From: drainage <drainage@midsussex.gov.uk>
Sent: 17 December 2024 15:18:02 UTC+00:00
To: "Stefan Galyas" <Stefan.Galyas@midsussex.gov.uk>
Cc: "drainage" <drainage@midsussex.gov.uk>
Subject: 2024.12.17 Re: DM/24/2219 - App - Minor - 17 Blackthorns Lindfield Haywards Heath West Sussex RH16 2AX

Thank you for consulting the Flood Risk and Drainage Team with regard to the above application. We understand the application is for minor extensions to the both the rear and front of the dwelling. The Flood Risk Assessment provided by the Applicant has been reviewed, and we would comment as follows:

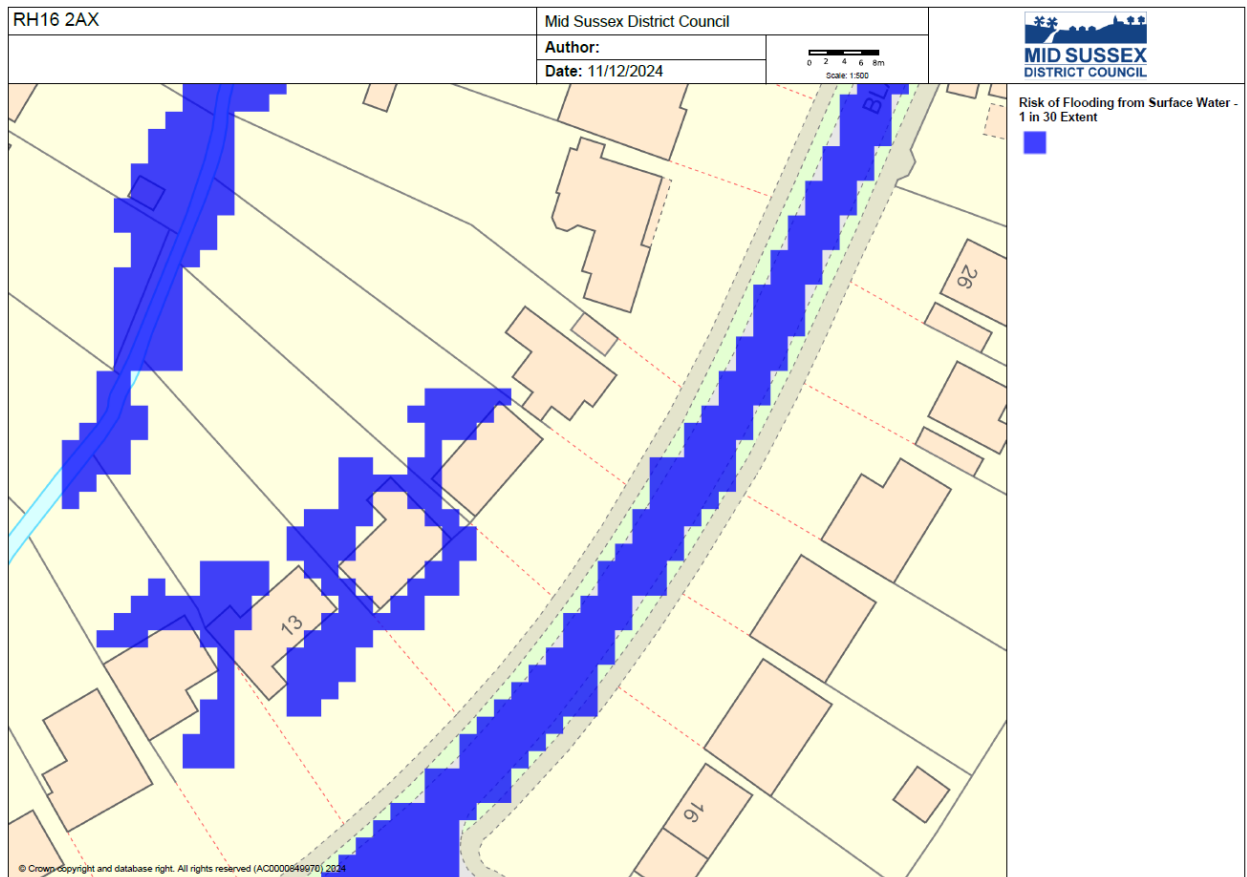
The site is in flood zone 1 and is at low fluvial flood risk (risk of flooding from Main Rivers). The site is shown to be at very low, low, medium, and high surface water flood risk (comparable to flood zone 3b, 3a, 2 and 1).

The proposed development site is located within an area impacted by the 1:30, 1:100 and 1:1,000 flood events (high, medium, and low surface water flood risk). Following the approach set out under the NPPF for assessing fluvial flood risk (flood zones) this area would be considered consistent with Flood Zone 3b (1:30 extent), Flood Zone 3a (1:100 extent), and Flood Zone 2 (1:1000 extent).

Based on the latest guidance that all sources of flooding should be considered consistently the site meets one of the reasons an area would be considered functional floodplain (Flood Zone 3b); it's location within the 1:30 surface water flood extent.

It is the Flood Risk and Drainage Team's findings that, following the latest guidance on assessing flood risk the site is located within the equivalent of Flood Zone 3b (1:30 flood extent) and the proposed development is a more vulnerable development.

As per the Environment Agency standing advice for minor extensions, development within the 1:30 flood extent is not permissible. In the event that the proposal is outside of this extent then additional resistance and resilience mitigation will need to be evidenced at this location, as this development is classified as 'more vulnerable'

In addition, the Flood and Drainage Team would have no objection to the scheme if surface water modelling can be provided which demonstrates that the development design ensures that, for the 1:100 year + climate change event:

- *Site users are safe in the event of a flood*
- *There is no loss of floodplain storage*
- *There is no impedance of overland flows*
- *There is no increase in flood risk*
